Christie's Planning Study - City-initiated Secondary Plan and Zoning By-law - Technical Amendments

Date: June 17, 2022

To: Planning and Housing Committee

Attachment 1: Zoning By-law Amendments

9. Block Lines

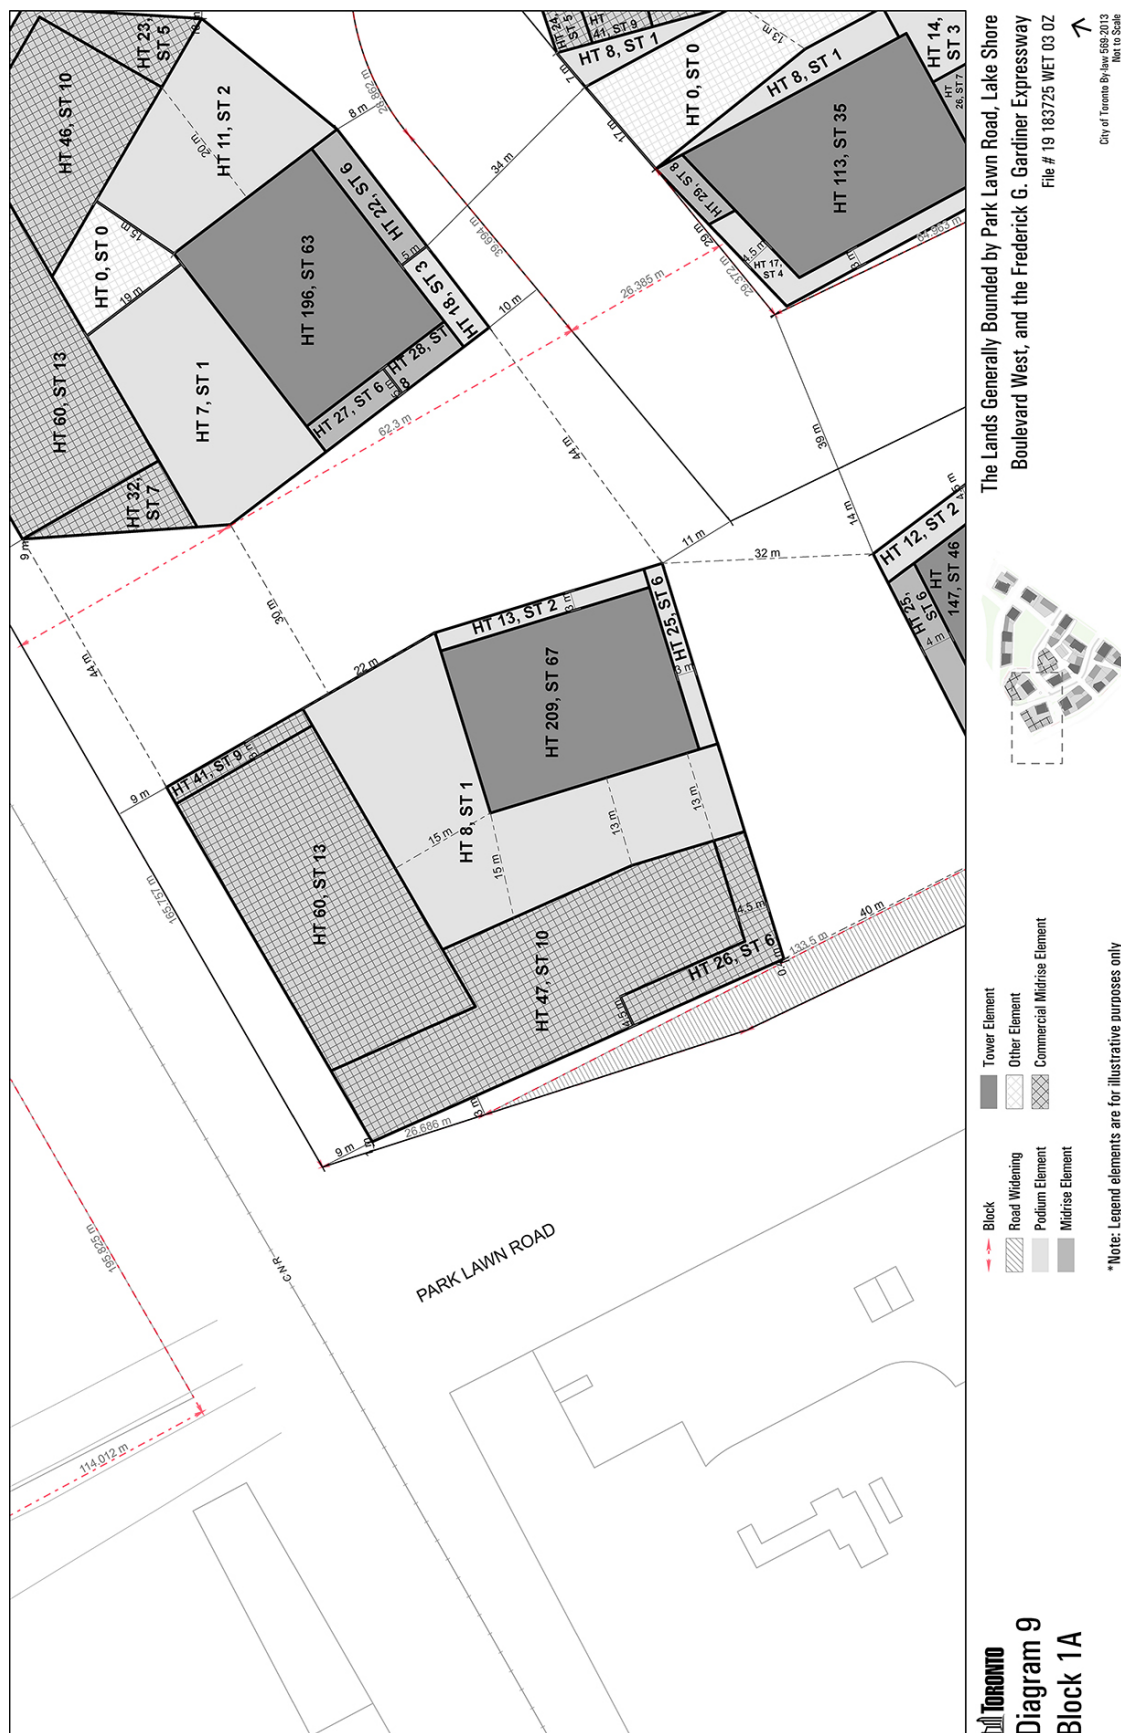
For the purpose of this exception, Blocks are lots and Block lines are lot lines.
